# ADDENDUM TO CONTRACT DOCUMENTS

**Project:** **Conrad School of Science Athletic Fields**  
Wilmington, Delaware

**Subject:** **ADDENDUM NO. 02**

**SOFTBALL BACKSTOP DETAIL**

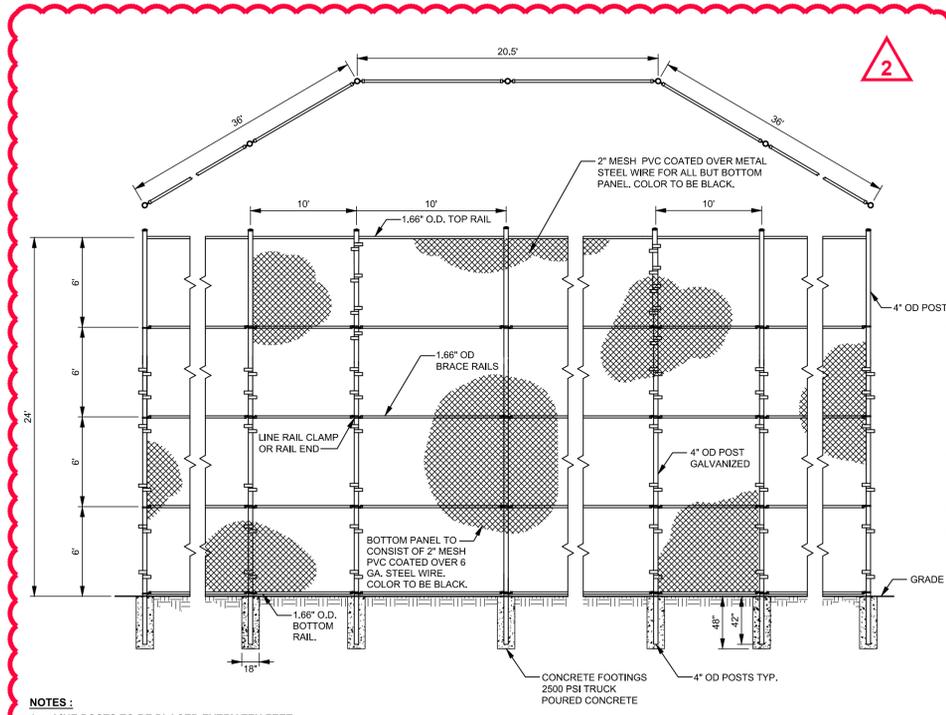
Item	Description
1	Q: On the softball backstop the plan says 24'H however on the detail is shows an 18'H backstop, also the detail shows a 20' Back x 25' Wings, however when you scale it on the plan it shows 20' Back x 40' Wings. Which is correct? A: Detail dimensions revised. See Conrad Phase 1 – Sheet C-902 attached.
2	Q: On the baseball backstop the detail shows 50' Back x 50' Wings, however on the plan it scales 25' Back x 50' Wings which is correct? A: Detail dimensions revised. See Richey Plans – Sheet C-901 and C-902 attached.
3	Q: The right field fence on the softball field is a bit confusing, I believe 115 LF of the right field fence is going to be the existing tennis court fence? Is that correct?

Item	Description
1	Conrad Phase 1 – Sheet C-902 – Softball backstop and gate clarifications.
2	Conrad Phase 2 – Sheet C-201 – revised Note G-5 Retaining Wall revised Note G-11 Chain link Fence
3	Conrad Phase 2 – Sheet C-401 – revised grading (southwest corner) as shown.
4	Conrad Phase 2 – Sheet C-901 – added Chain Link Fence Detail
5	Conrad Phase 2 – Sheet C-903 – added Retaining Wall Detail, Chain link Fence Detail (Surface Mount) and Fence Post Base Plate Detail.
6	Richey Elementary – Sheet C-901 – Baseball backstop and gate clarifications.
7	Richey Elementary – Sheet C-902 – Baseball backstop and gate clarifications.

**C-201**

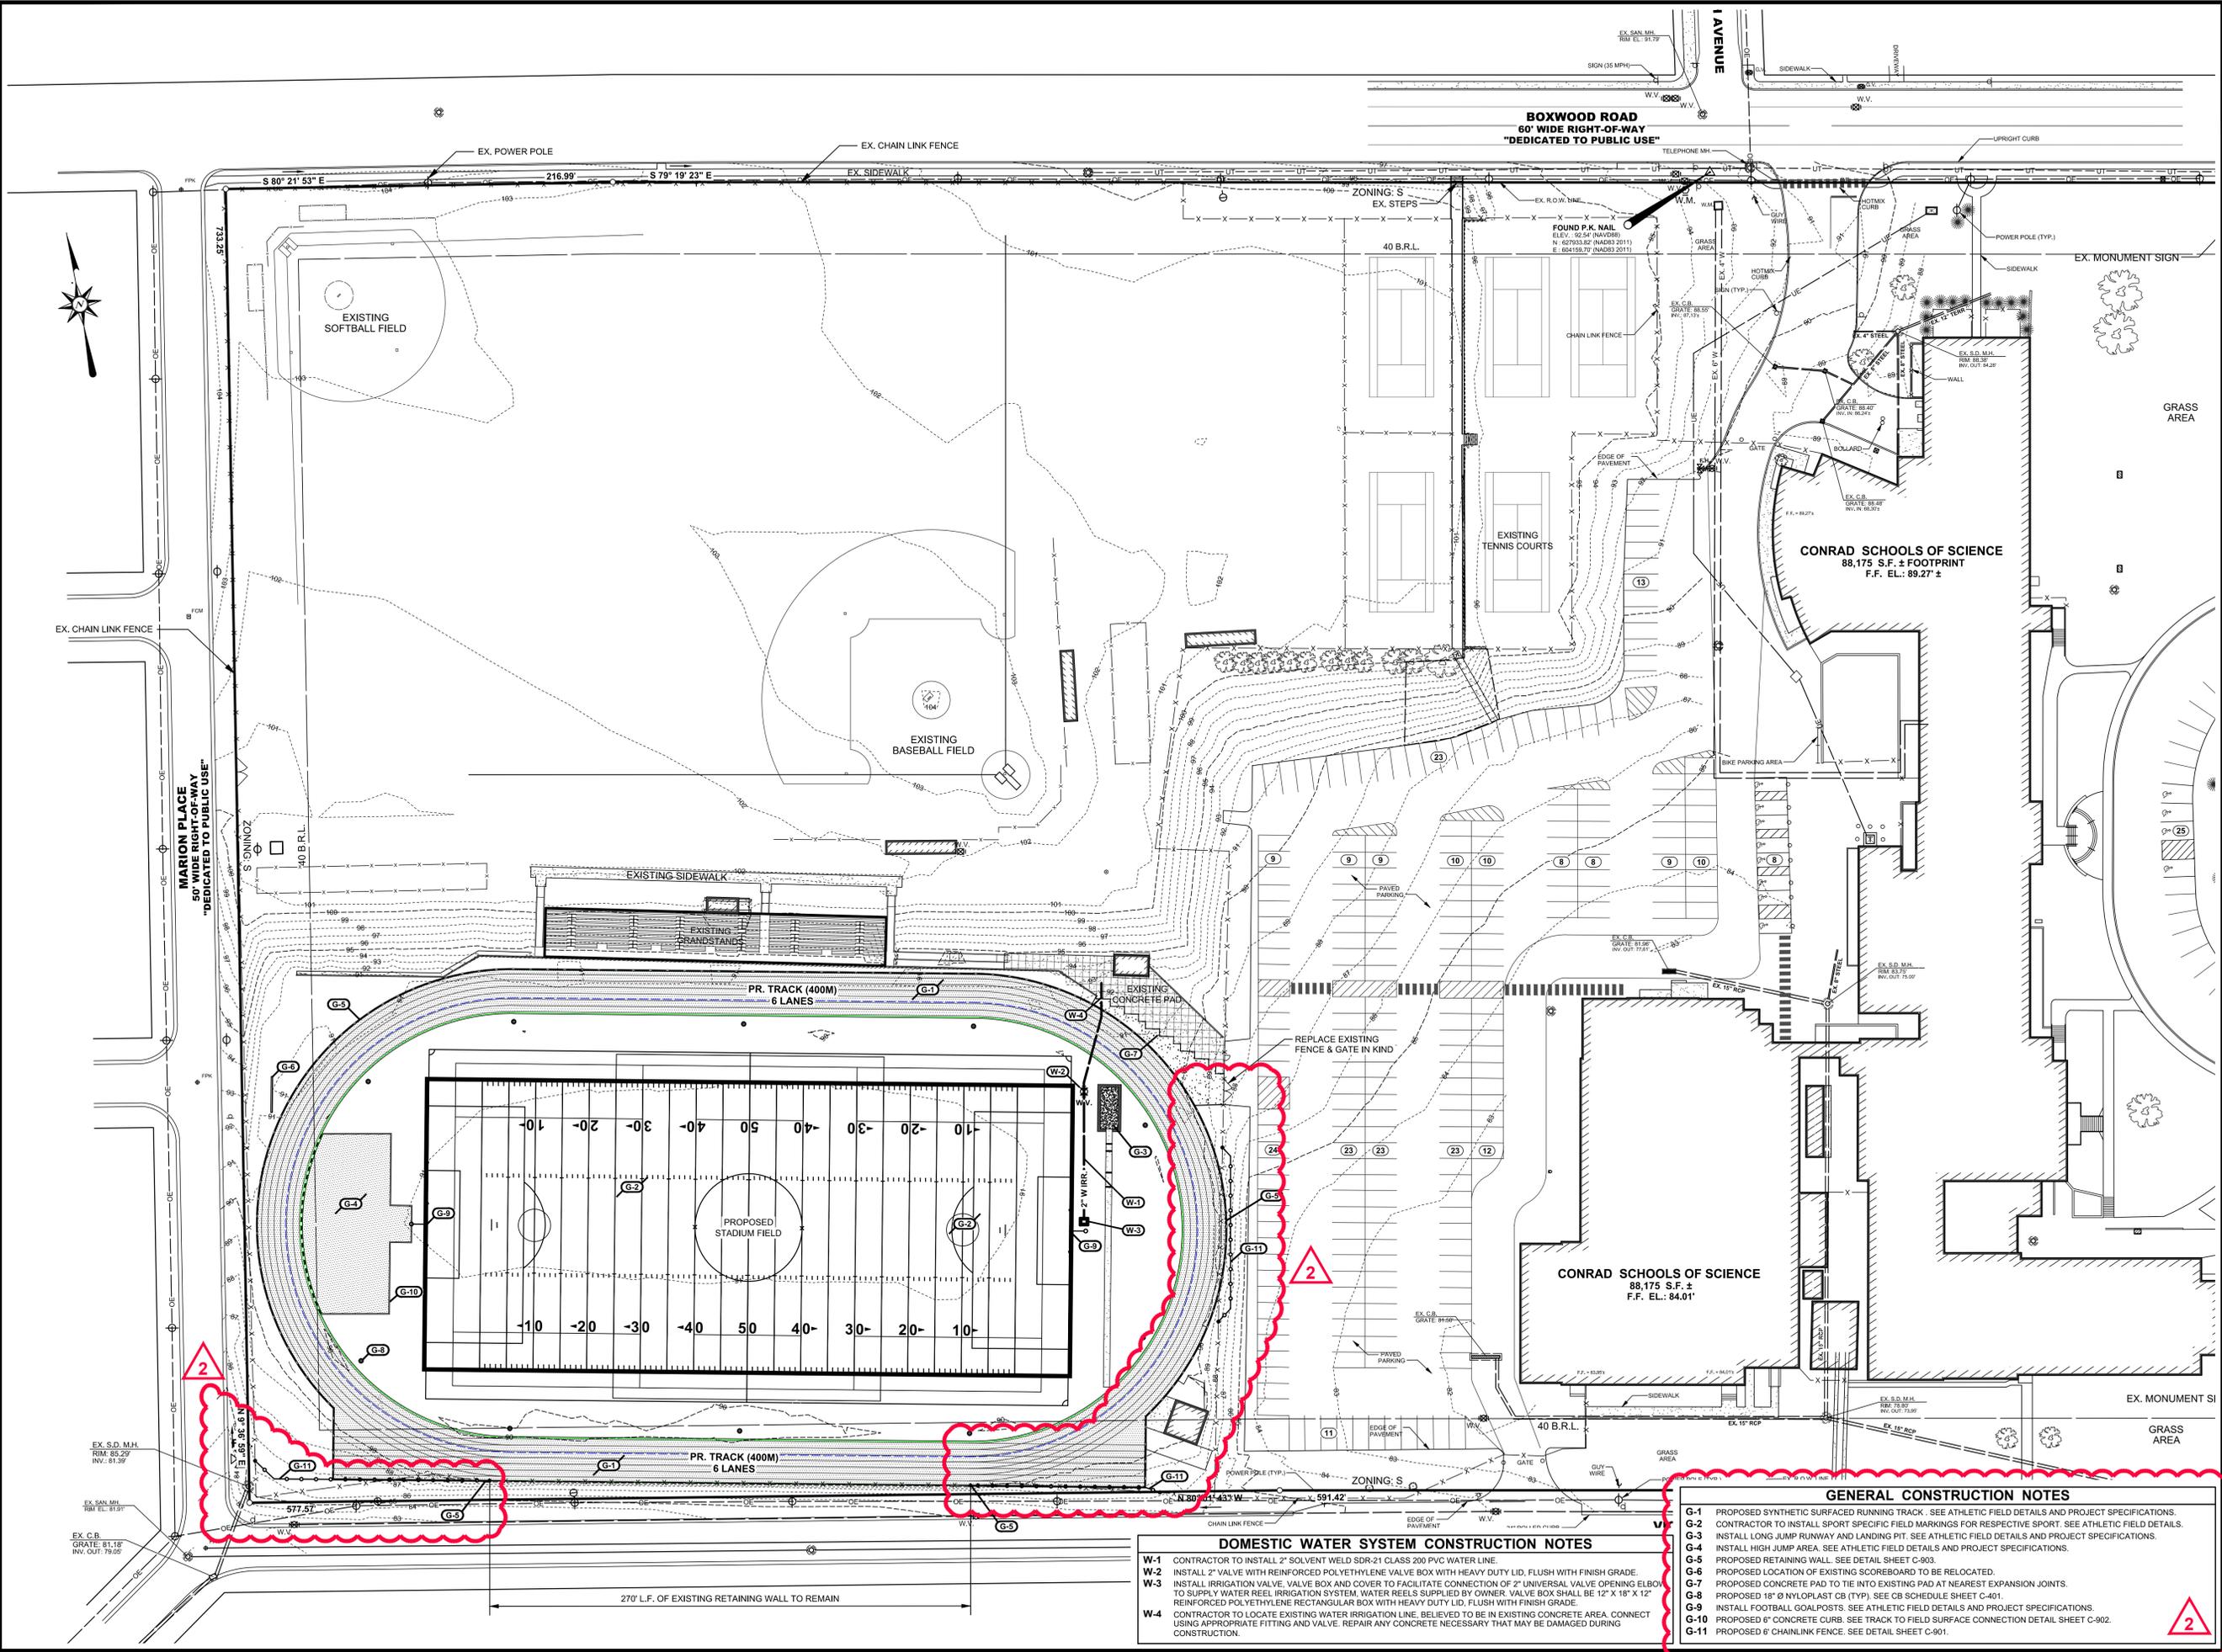
3	Q: In addition on plan sheet C-201, item G-5 calls out for a proposed retaining wall per architectural plans. I don't see any detail for a retaining wall. There is currently an existing concrete wall around outside of football field. A: Retaining wall detail and wall mounted fence detail provided with this addendum.
<b>A-Del Construction RFI 01</b>
